**Critique of Cedar Point Wind Project  
Acoustic Assessment Report  
Prepared for Suncor Energy Products Inc.  
Critique Prepared By:  
Richard R. James INCE, E-Coustic Solutions, Okemos, MI  
Date: March 24, 2013**

This critique addresses errors and omissions in the January 25, 2013 Draft Acoustic Assessment Report (AAR), prepared by HGC and included as Appendix B (Noise Assessment Report) of the Draft Design and Operations Report prepared for Suncor Energy Products, Inc. by Stantec Consulting Ltd.. The documents are available to the Town of Plympton-Wyoming and the public as part of the Draft Renewable Energy Approval Documents. The draft documents reviewed in this report were obtained from the Suncor Energy Cedar Point Wind Power Project web site at:

**Figure 6-Histogram of AAR Table 5 with annotation showing additional impact if tolerances are included**

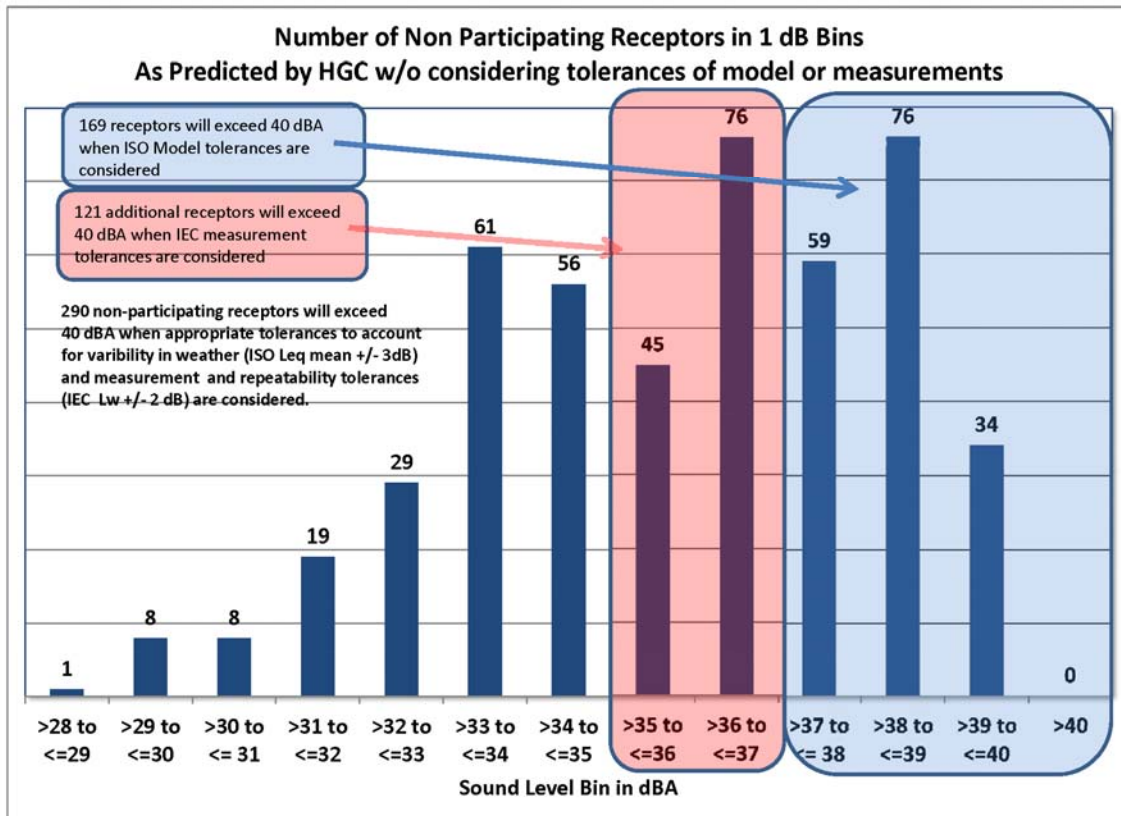
The histogram in Figure 6 (also Exhibit I) was constructed using the HGC AAR Table 5 listing the non-participating receptors and predicted sound level without considering the ISO tolerances for weather variability. If the ISO variability of  $\pm 3$  dB is added to the values in Table 5 or HGC AAR

If the AAR model had included a combined +2 and +3 dB adjustments to account for the tolerances, as described in the FOIA quotation of Finding 1, then 290 of the noise receptors in HGC's Table A5 cumulative receptor noise level summary table would exceed the 40 dBA limits of the MOE Guidelines. This means all non-participating receptors with a predicted sound level of 35.1 dBA or higher would exceed the 40 dBA limit. This would put 32% of the non-participating noise receptors inside the study zone over the limit.

With the adjustments for day to day variability and nighttime operations it is reasonable to conclude that **290 noise receptors or vacant lot surrogates exceed the 40 dBA threshold within the confidence limits of both the modeling and measurement protocols.** Without that adjustment, as the data is presented in Tables A5 there can be no confidence in any claim that noise receptors or vacant lot surrogates will be under the 40 dBA threshold.
